Attached are EGLEs comments on the Area 1 PDIWP Addendum 7 – Remedial Reach Sediment Sampling Work Plan. Per your request I provided a Word and PDF copy of the comments. Please let me know if you have any questions.

**Kalamazoo River Superfund Site
Area 1 Pre-Design Investigation Work Plan – Addendum 7
Remedial Reach Sediment Sampling
Prepared by Wood Environment & Infrastructure Inc.
Dated Oct. 15, 2019**

FIGURE
1-4a

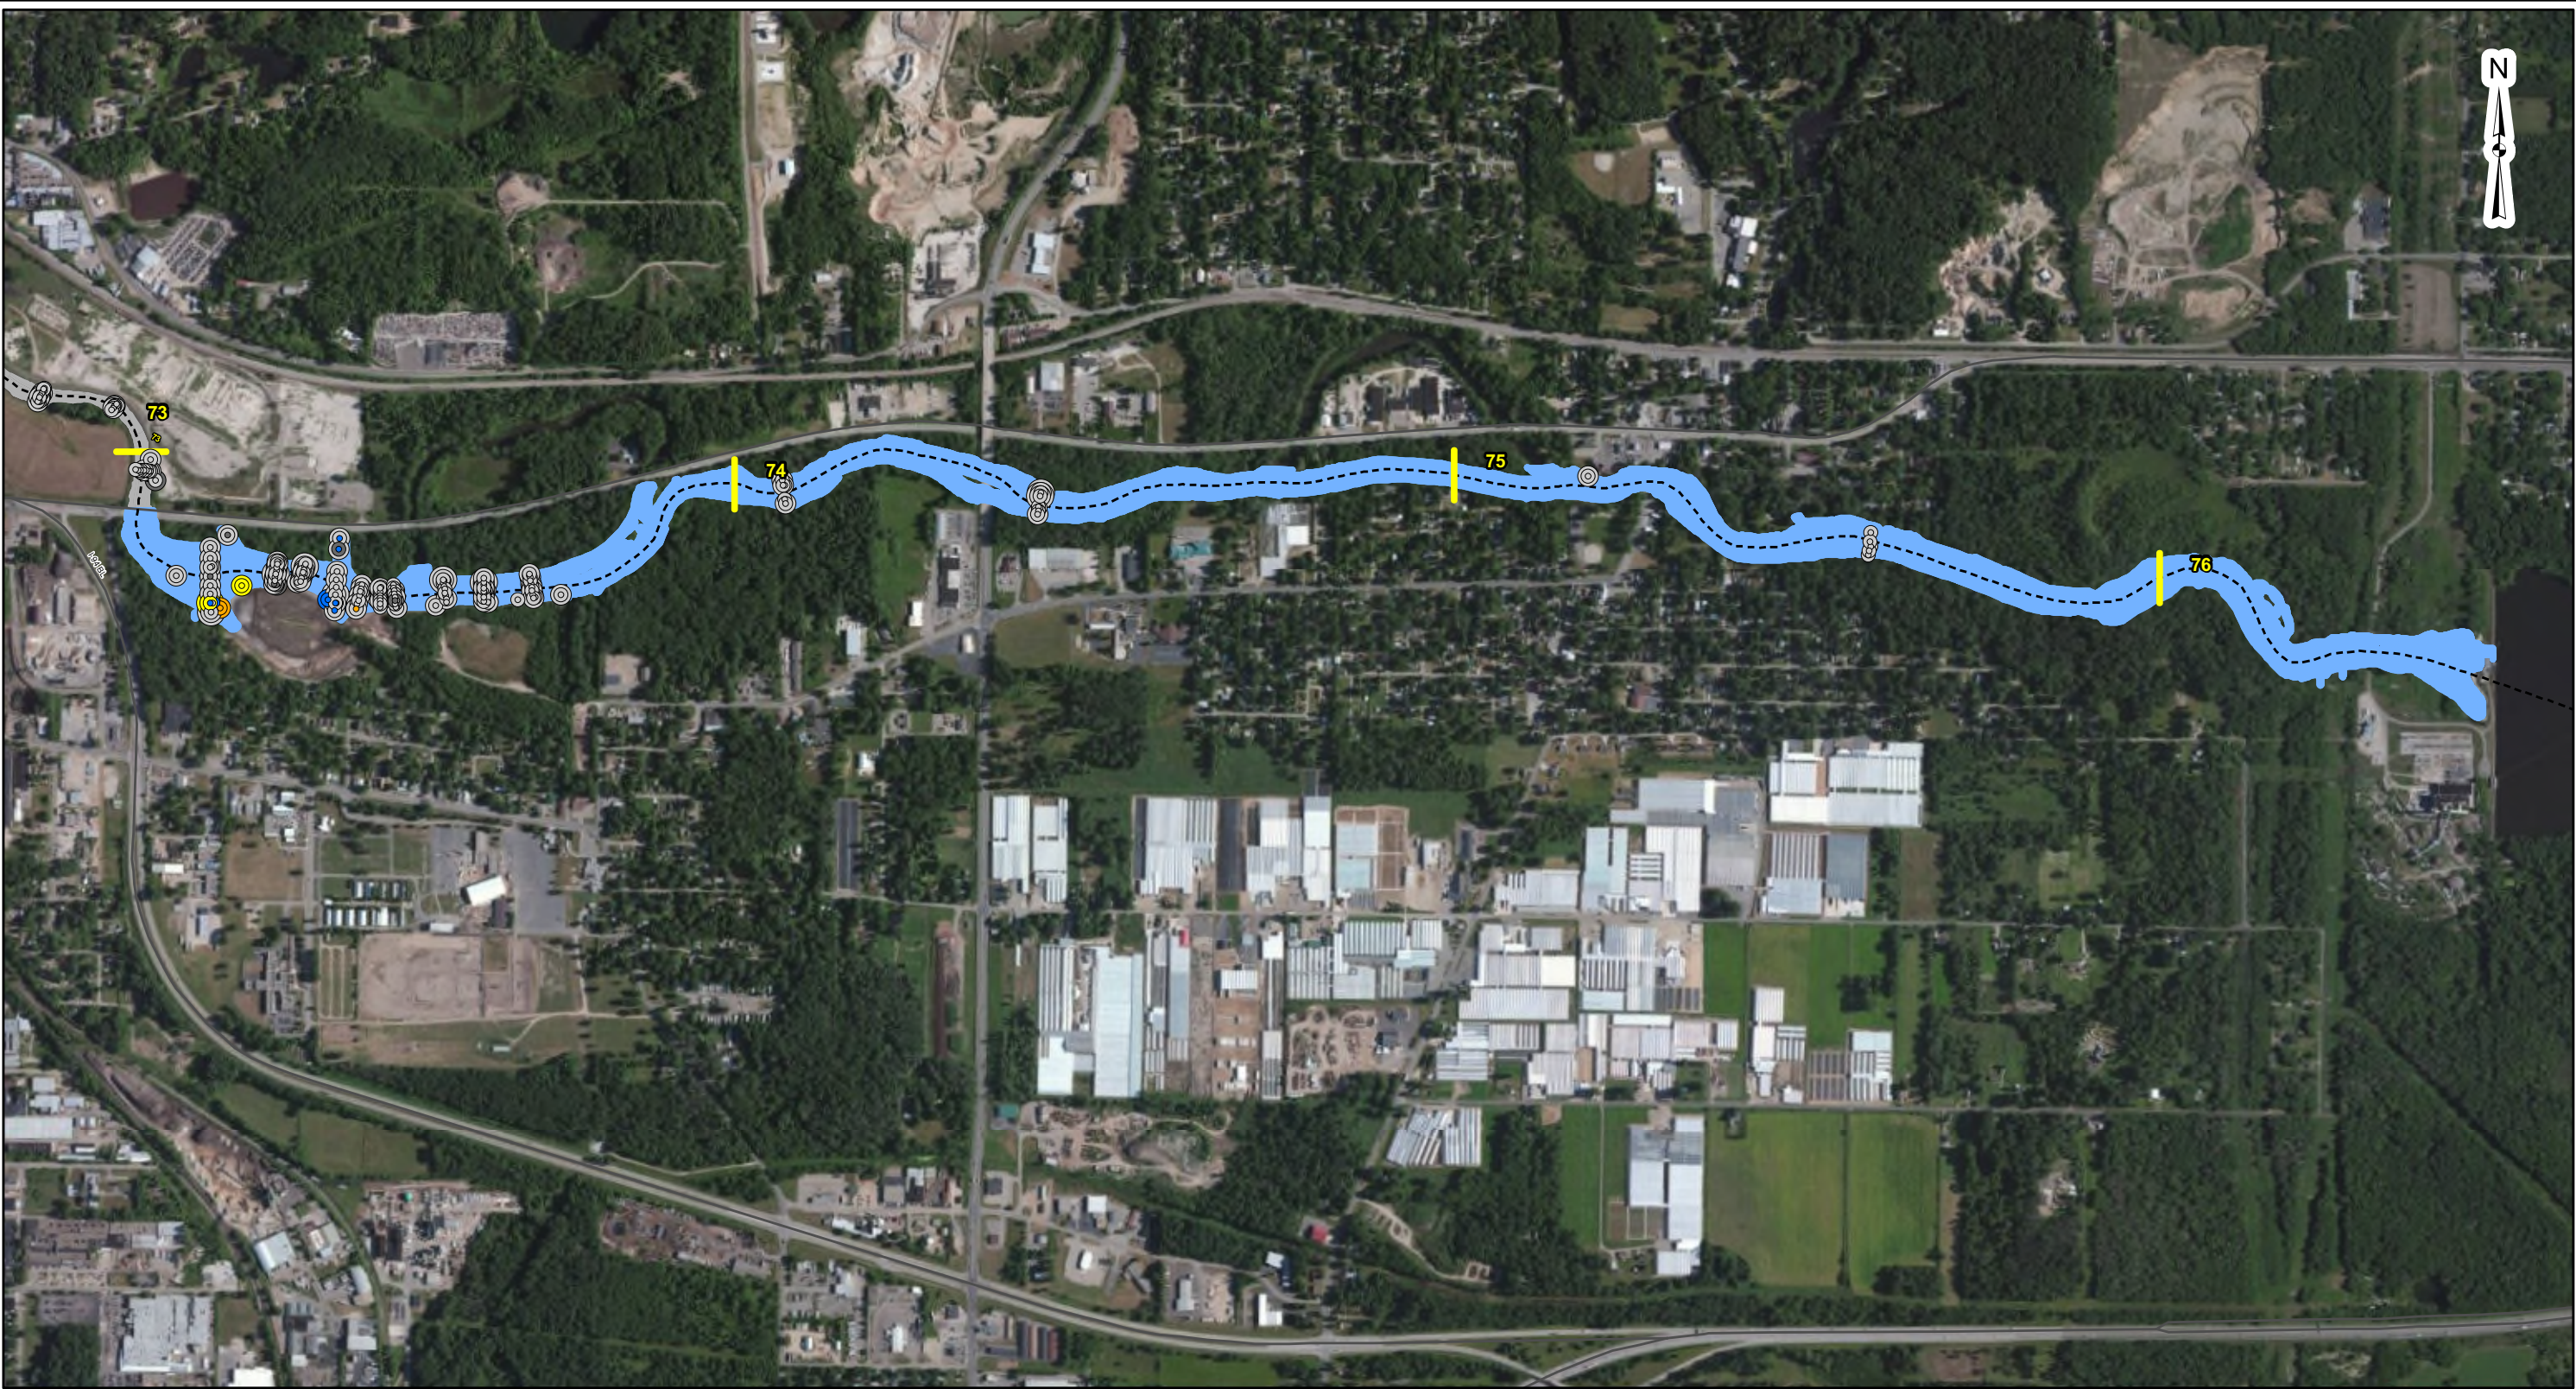
Figures presented in the Area 1 Feasibility Study (FS) (Figures 1-4a, 1-5b and 3-9a) show elevated polychlorinated biphenyl (PCB) concentrations in Section 1 that are further upstream than where additional samples are proposed in the Work Plan and the FS even proposed removal of tubes near the former mill properties and Operable Unit 2. EGLE requests that sampling be completed from Morrow dam to the furthest upstream hotspot (KPT-19) to prevent incomplete delineation and delays in the remedial design and is unsure why the full extent of Section 1 was not sampled as part of the pre-design sampling plan since multiple sources of PCBs have been documented in Section 1.
